Summary and Analysis of Comments: Control of Emissions from Unregulated Nonroad Engines

EPA420-R-02-023
September 2002

Assessment and Standards Division
Office of Transportation and Air Quality
U.S. Environmental Protection Agency

Figure II.F-1: NTE Zone for Recreational CI Marine Engines

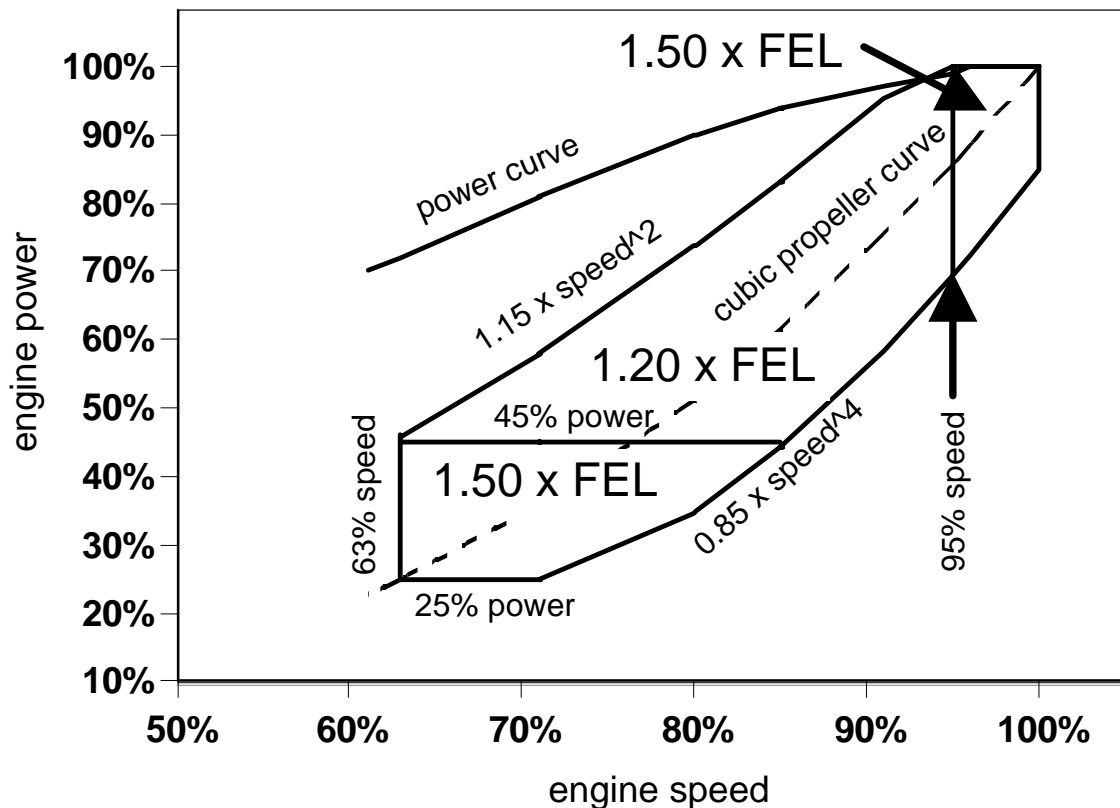
The shape of the proposed NTE zone is presented in Table V.C-1 of the October 5,

2001 proposal (66 FR 51098). This zone is based on a range around the cubic propeller curve used in the ISO E5 duty cycle and is shown in Figure II.F-1. All operation below 63 percent of maximum test speed and all operation below 25 percent of maximum test power are excluded from this zone. In addition this NTE zone is split into three subzones with different emission limits. Only steady-state operation is included.

Figure II.F-2: Operational Test Data for Planing Hull Vessel

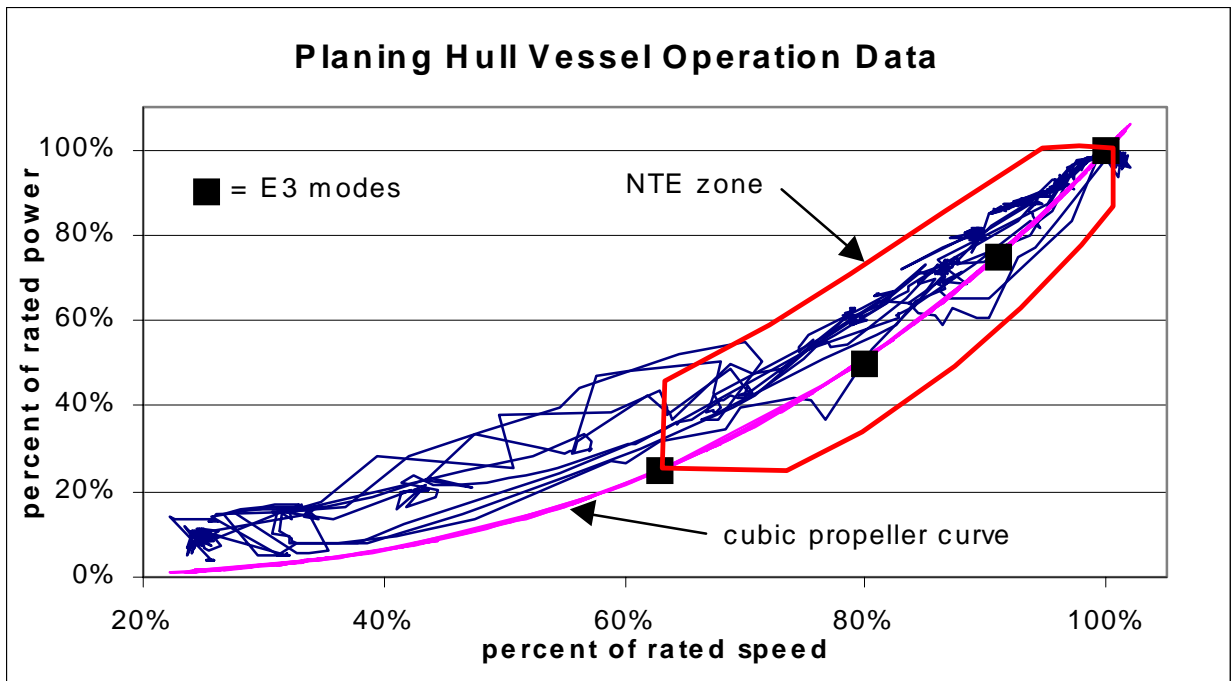
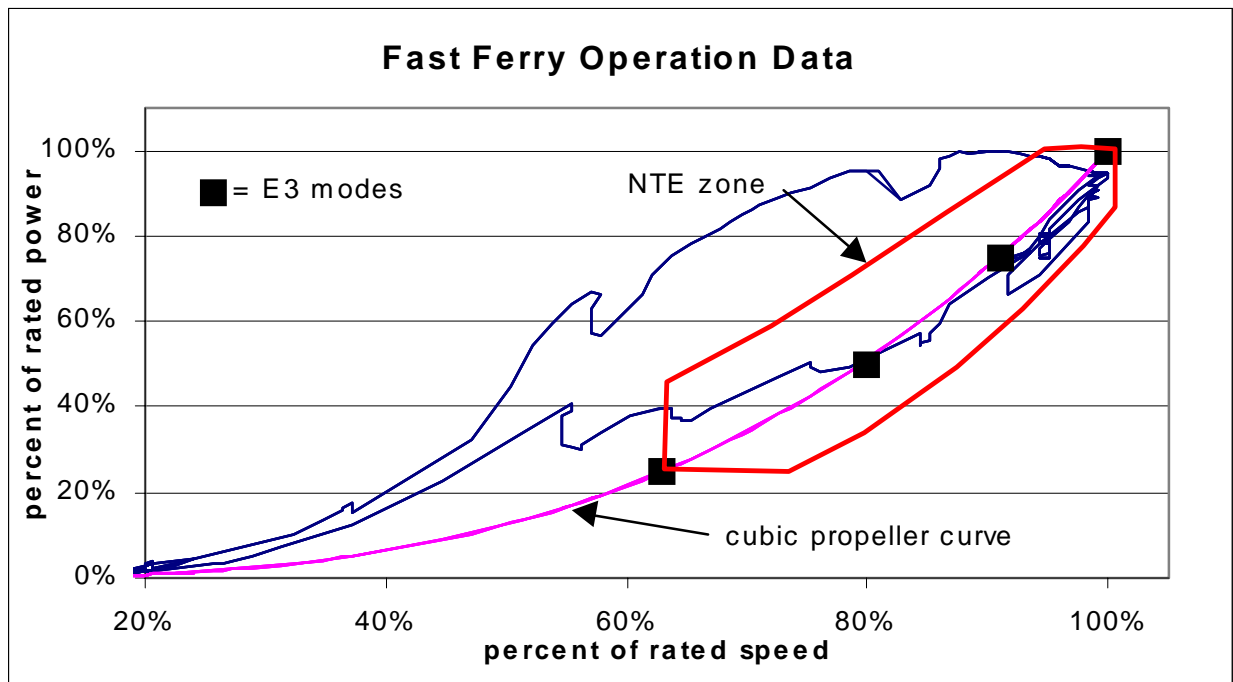
indicated that an engine coupled to a fixed pitch propeller curve typically operates along the prop curve at steady-state” as evidence that marine engines operate on a cubic propeller curve. However, as shown in Figures II.F-2 and 3, the propeller curves for the vessels discussed in the Spears memo that operate on propeller curves are not the theoretical cubic propeller curve. The statement in this memo was just making the point that boats generally operate on a propeller curve under steady-state operation and does not make any statement of what different propeller curves would look like for different boats. As with the discussion in Pounder’s Marine Diesel Engines (Sixth Edition), operation is not always along the theoretical propeller curve used in the E5 duty cycle.

When a propeller is properly matched to a boat, the propeller curve will pass through the rated power point of the engine's power map. Matching is performed by using the appropriate propeller geometry to generate the proper load at the rated speed. If the engine is overloaded, it will reach peak load before ever reaching rated speed. If the engine is oversped, it will reach rated speed without having to generate full power. In either case, the boat never uses the full power of the engine. Although it is usually to the operators benefit to match the propeller correctly, anecdotal evidence from manufacturers and boat builders have suggested that users do not always make optimized decisions from an engineering standpoint.

Even if the propeller were ideally matched for typical operation of a vessel (selecting the proper propeller type, size, and pitch for a given vessel form and size), changes in vessel loading and weather can affect the actual loading of the engine. The loading of the vessel can affect the actual propeller curve in two ways: changing the effective pitch of the propeller in the water and affecting the boat's resistance in the water. Weather can affect the propeller curve through wind and waves acting on the vessel. When propellers are matched to a vessel, they are designed to operate on a specific angle in the water; changing this angle by changing the angle the boat sits in the water will affect propeller loading at a given speed. The condition of the propeller can affect its operating characteristics. Also, changing the resistance on the boat can affect the propeller curve by changing the load on the propeller at a given speed. This is supported by the discussion of variables that affect engine operation discussed in comments made by Hatteras Yachts. Thus a vessel can be expected to operate differently than predicted by a single propeller curve associated with that vessel.

Figure II.F-4: Illustration from EMA Comments (NTE Zones Added)

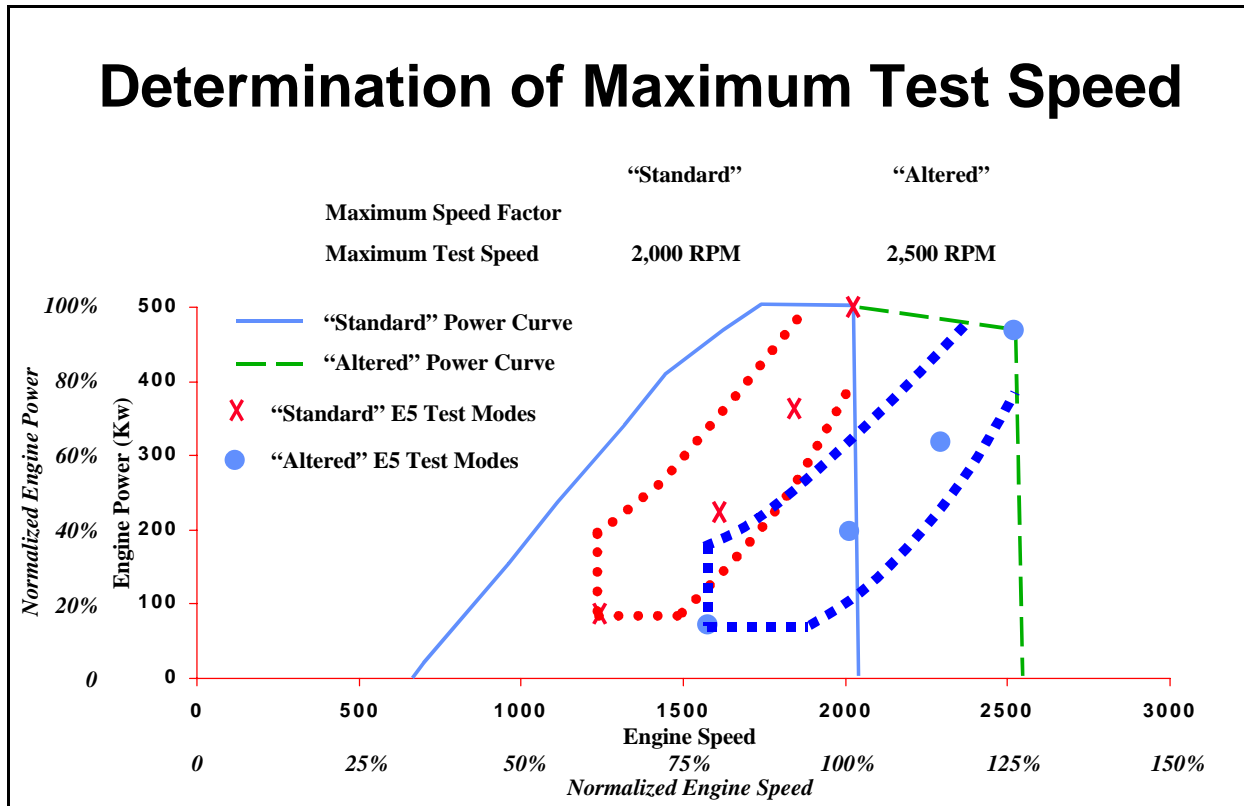
EMA's own discussion on defining the maximum test speed supports the need for including expanded operation beyond the theoretical propeller curve. They stated that a manufacturer could circumvent the standards by using a different maximum test speed than the recommended rated speed for the boat builder. This also provides an illustration of how the engine operation on a vessel could be sensitive to improper matching of the propeller and engine with a vessel. Figure II.F-4 shows the illustration submitted by EMA. We added the NTE zones for the two maximum test speeds to this illustration. Although this is likely a worst-case scenario, it supports the need for a NTE zone that is expanded beyond a theoretical propeller curve.
